Date: Nov. 30, 1999

To: T10 Committee (SCSI)

From: George Penokie (IBM)

Subject: Comments resolution for SPI-3 Letter Ballot

Figure 1 - Example of a differential calibration trace

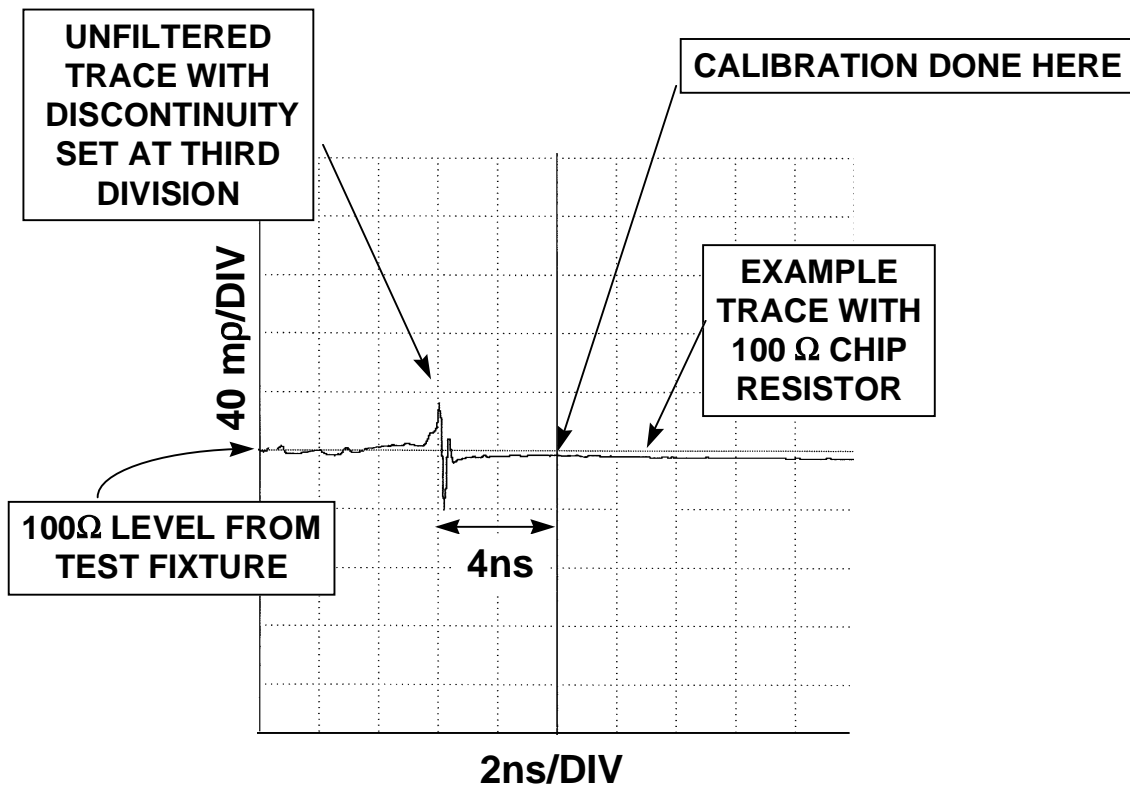
A figure is needed in section E.2.2.2.3 to illustrate the differential measurements.

Add the following words to section E.2.2.2.3 along with the Figure.

Figure x shows an example of a differential calibration trace.

**Accept**

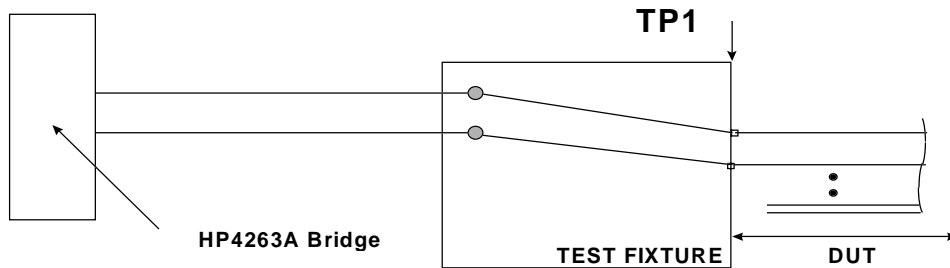
**SPI-3: 62.30) technical**

In section E.3.1.2

change: See E.2.2.2 for appropriate test fixtures.

To: Figure x shows the configuration to use for this measurement procedure.

Add the following figure x describing the test fixture to section E.3.1.2 with the title "Test fixture for single ended capacitance measurement".

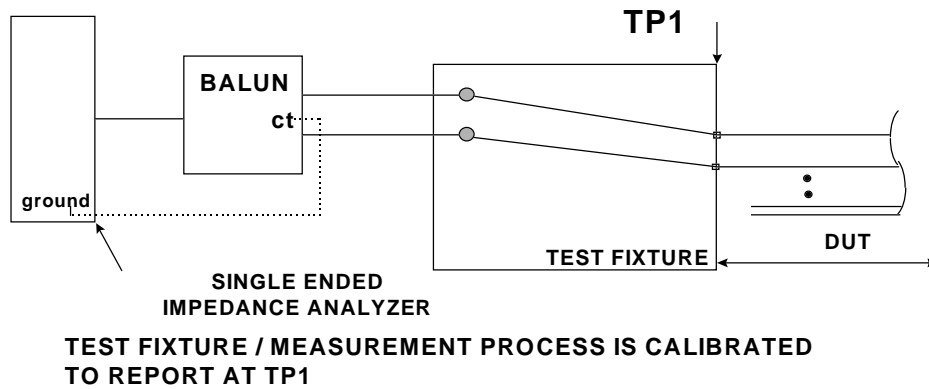
**SPI-3: 68.36) technical**

In section E.3.2.2

Change:

See E.2.2.2 for appropriate test fixtures.

Refer to Figure x for the proper test configuration.

[Add a new Figure x shown below titled "Test fixture for differential capacitance measurements"].

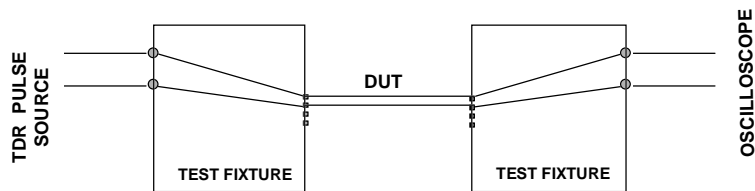
**SPI-3: 78.46) technical**

In section E.5.2 change:

To: See Figure x for appropriate test fixture.

Add new figure x given below showing the test fixture with the title "Propagation time measurement setup".

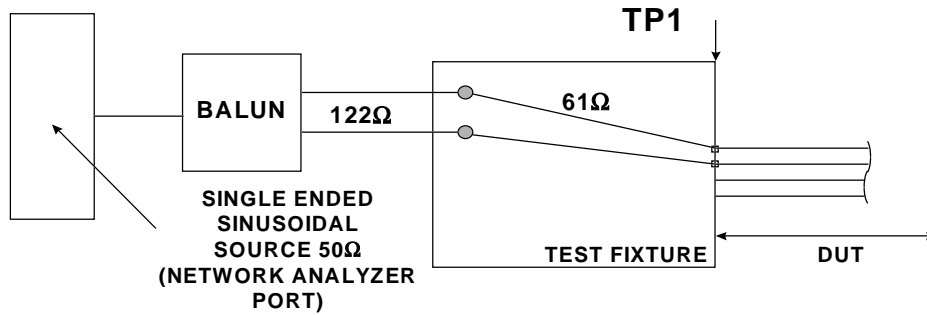
In section E.7.1.1 change

A test fixture having 75  $\Omega$  single ended paths for each signal line is used for the measurement as shown in

To:

A test fixture having 61  $\Omega$  single ended paths for each signal line is used for the measurement as shown in

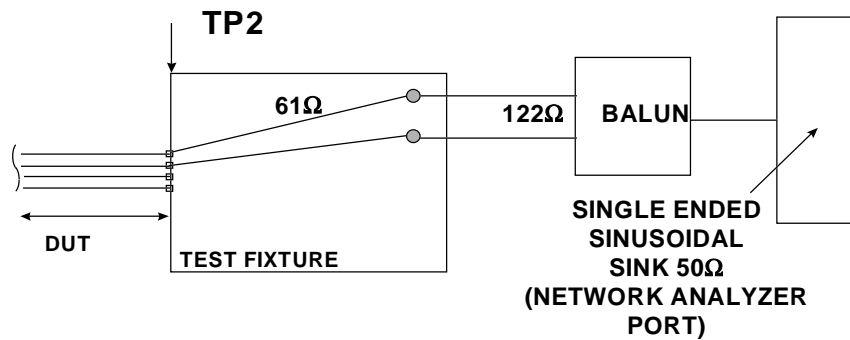
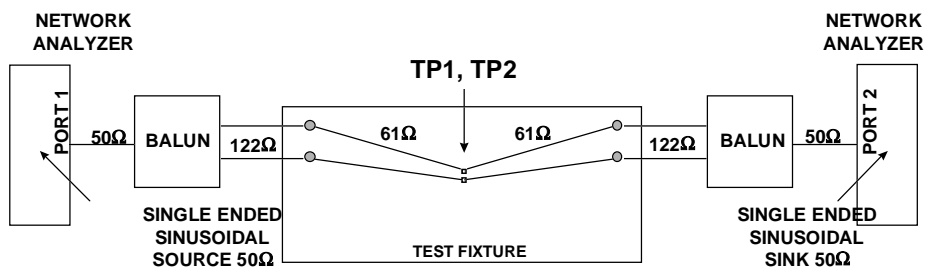
In section E.7.1.1 replace Figures E.12, E.13, and E.14 with the following respective figures: (same figure titles)

Accept

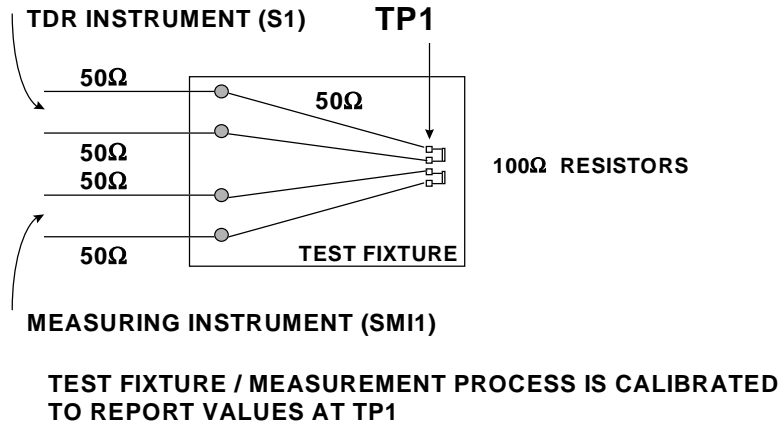
In section E.8.3 change Figure E.17 to:

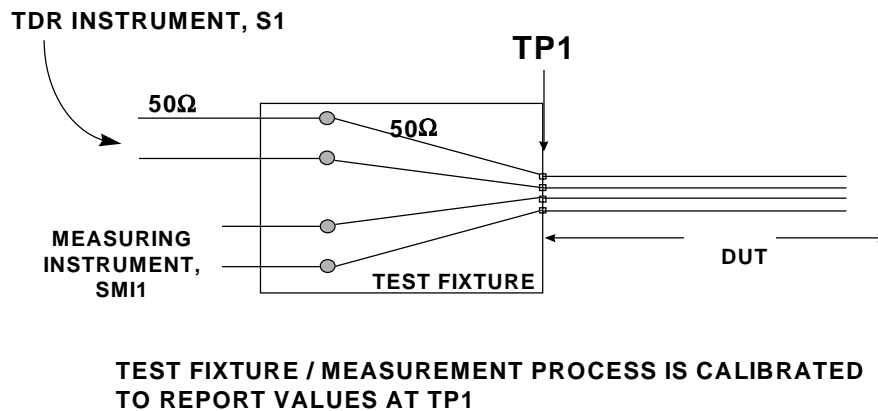
In E.8.4 change: Figure E.18 to:
